## ADDENDUM

Project: Castroville Clinic  
Castroville, Texas 78009

Addendum No: 2

Project Name: Castroville Clinic Renovation

**1 LIGHTING FLOOR PLAN - NEW WORK**  
SCALE: 1/8" = 1'-0"

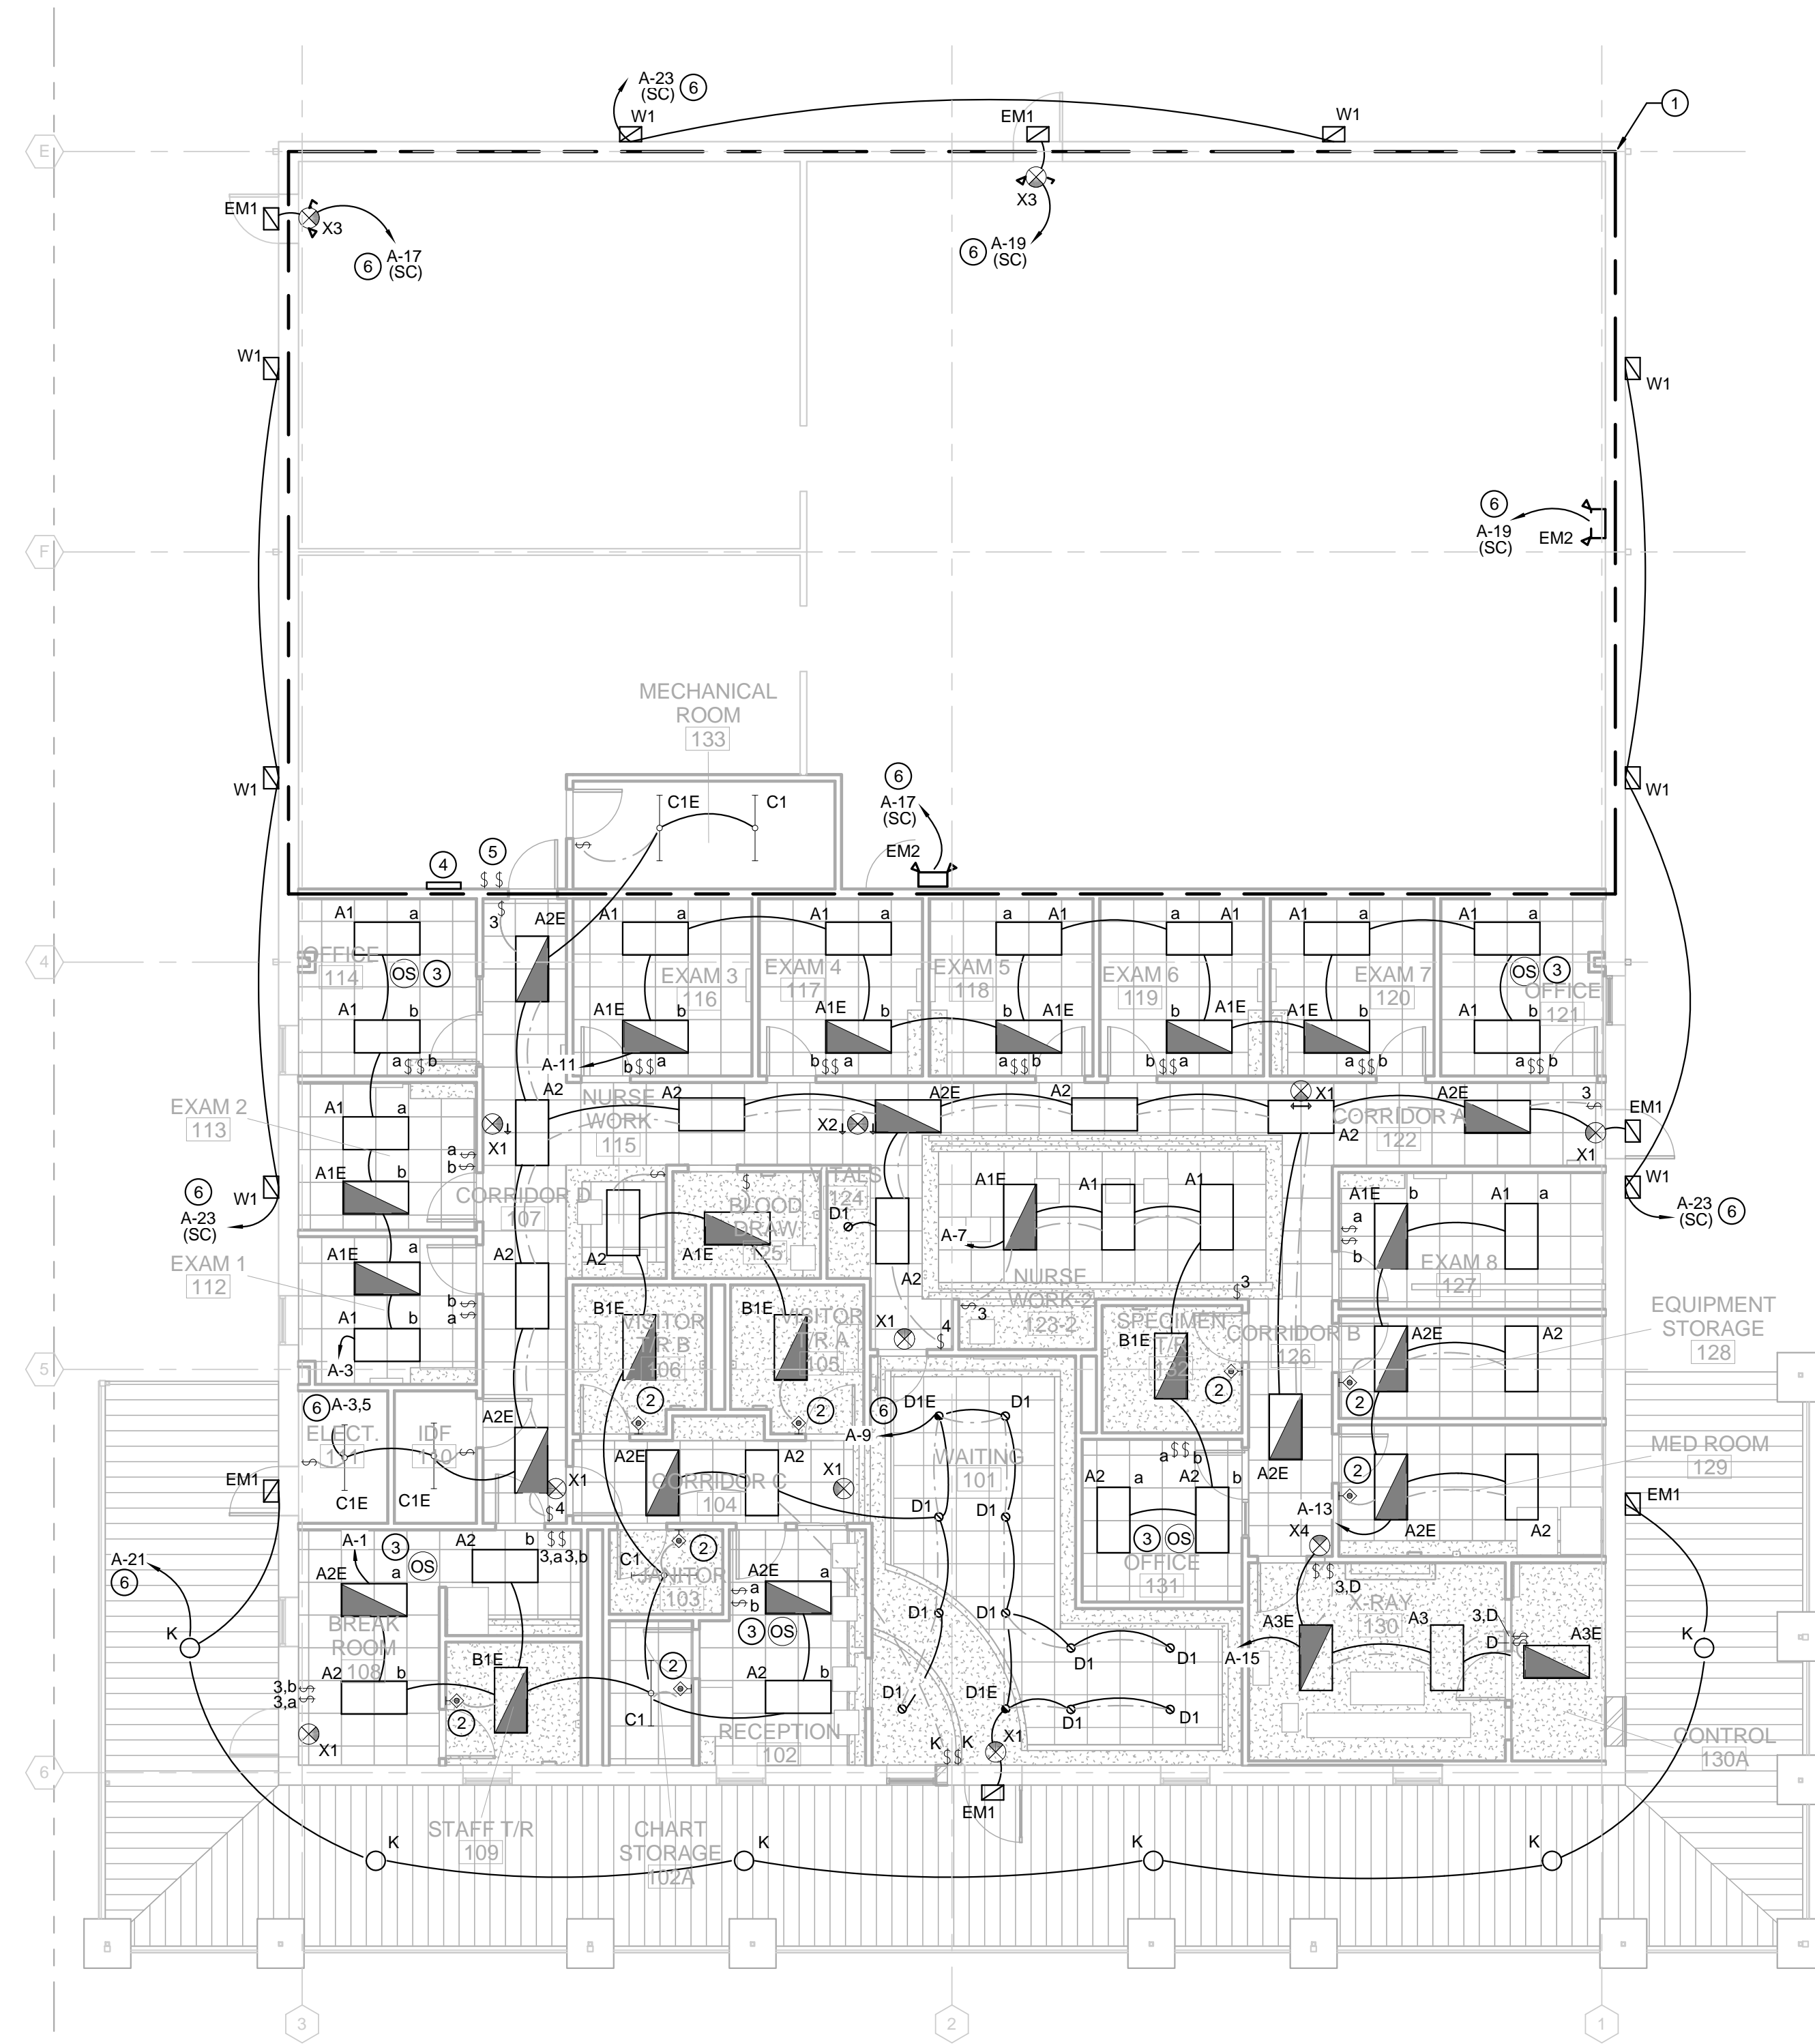
RE: Plan Sheet E-101:

Item 1: Revised Keyed Note #6.

5. PROVIDE NEW SWITCHES FOR CONTROL OF EXISTING LIGHT FIXTURES IN THIS AREA.
6. ROUTE LIGHTING CIRCUIT THRU LIGHTING CONTROL PANEL. CONNECT EMERGENCY RELAY DEVICE UP EXIT AND/OR EGRESS LIGHT FIXTURE TO NORMAL POWER LIGHTING CIRCUIT SERVING THE SAME AREA AND CONNECT EMERGENCY BATTERY CONDUCTOR AHEAD OF LIGHTING CONTROL PANEL AND ANY SWITCHES OR PHOTOCELLS. EMERGENCY EGRESS LIGHTING SHALL BE SWITCHED WITH NORMAL LIGHTING UNLESS NOTED OTHERWISE WITH "NL" (NIGHT LIGHT). REFER TO INTERIOR LIGHTING CONTROL DETAIL #2 ON SHEET E-002 FOR ADDITIONAL INFORMATION.

**2 LIGHTING CONTROL DETAIL**  
 SCALE: NTS

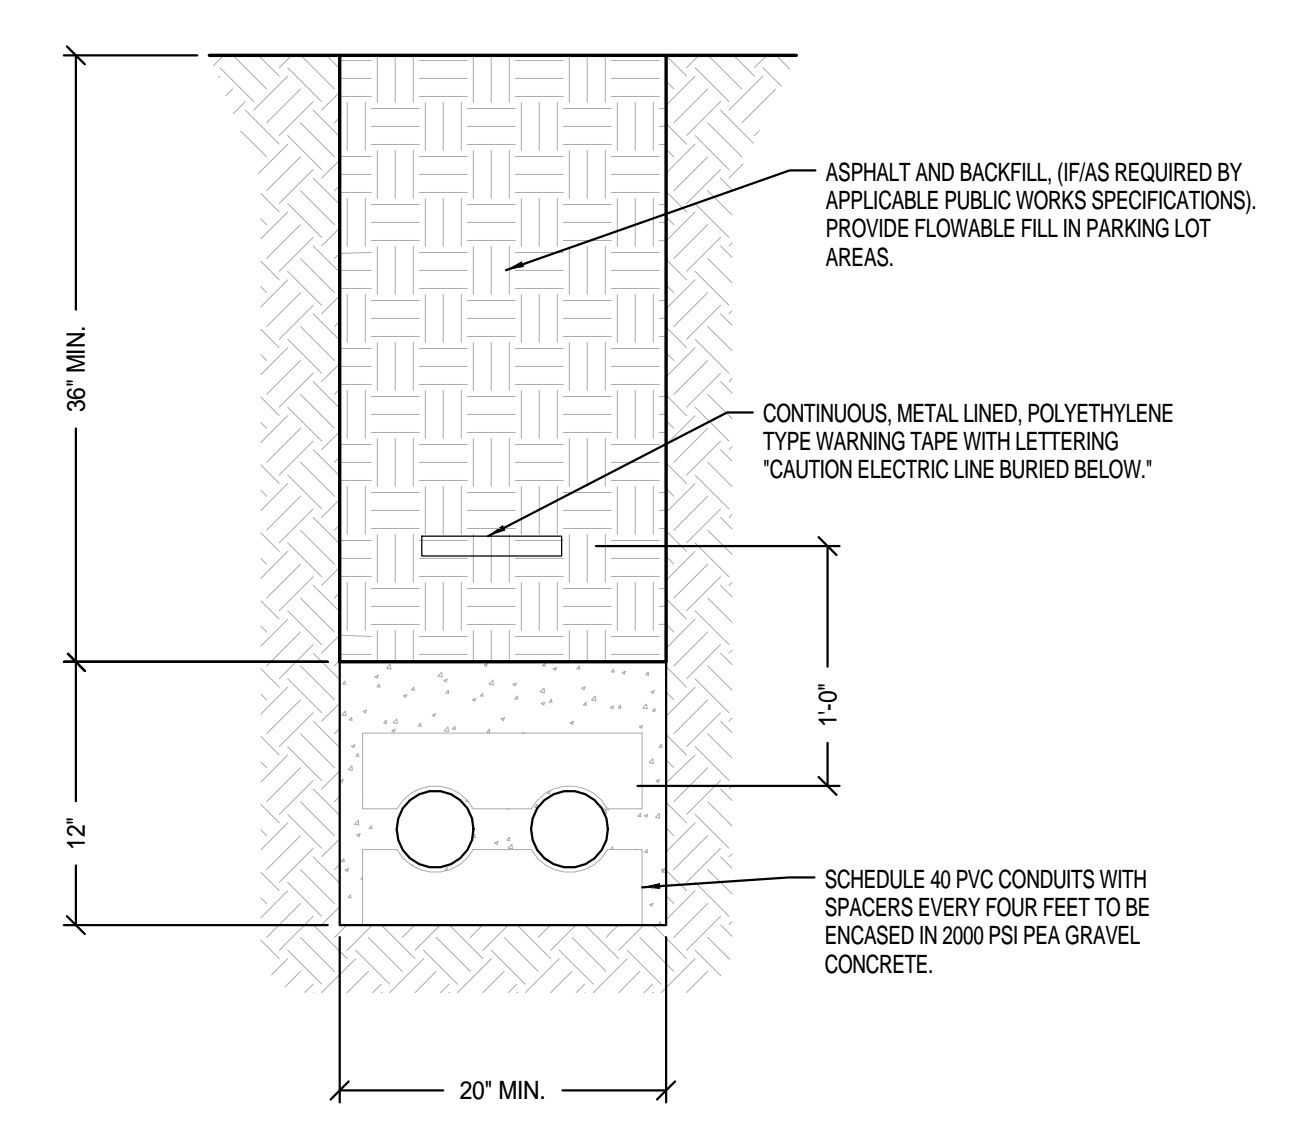
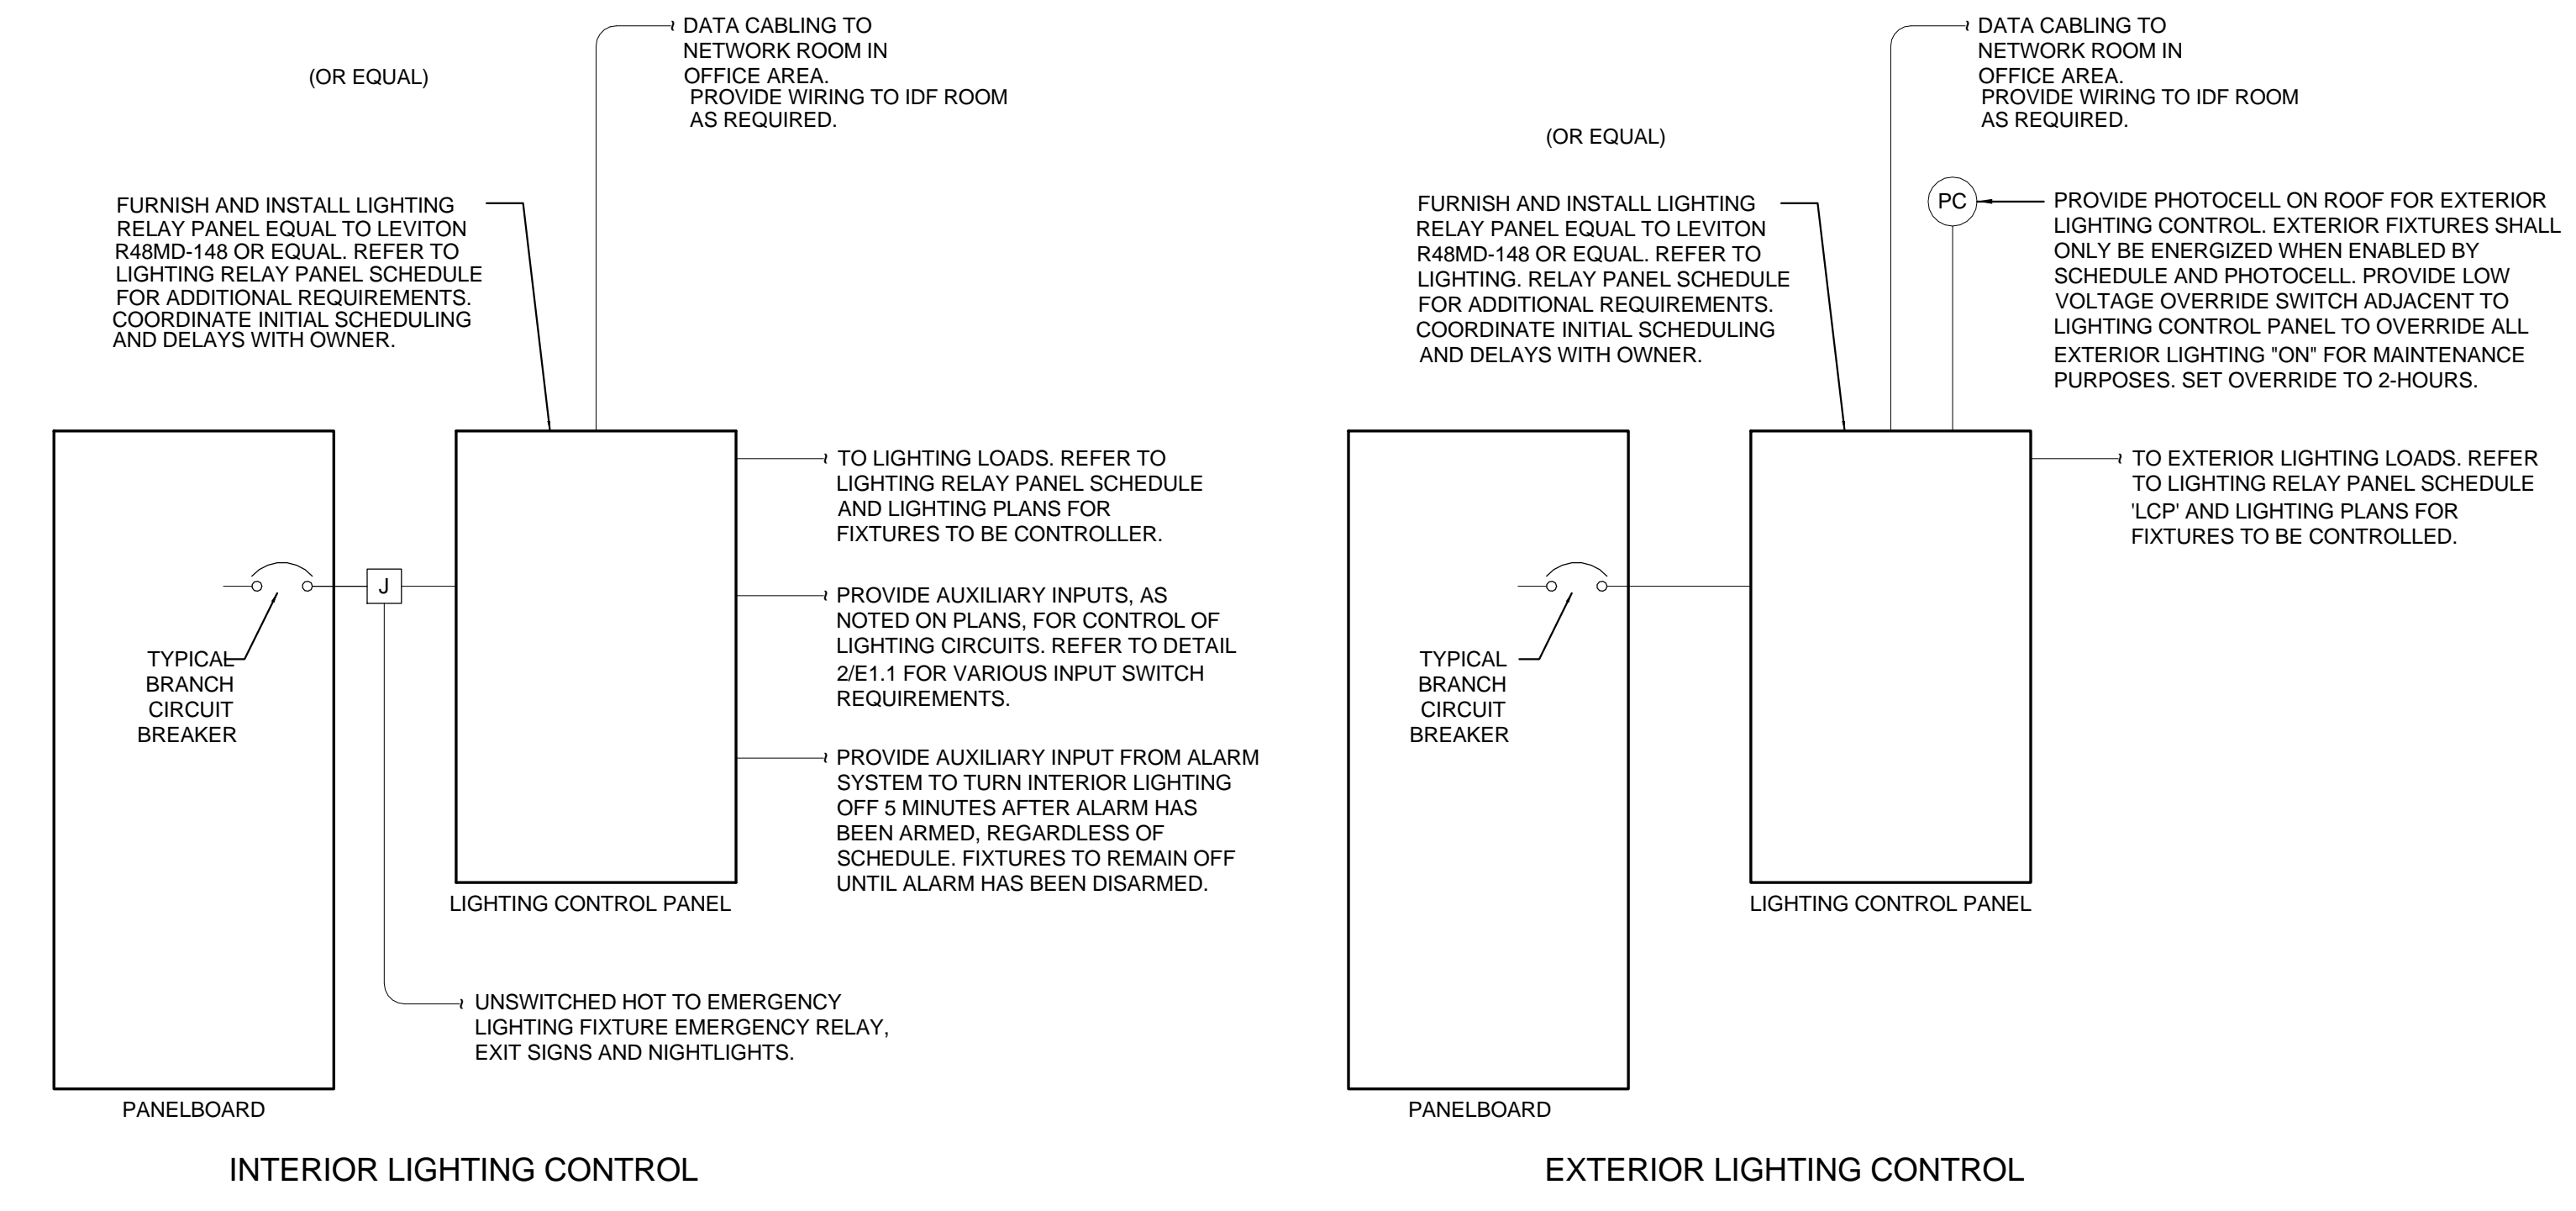
RE: Plan Sheet E-401:

Item 1: Revised detail #2.
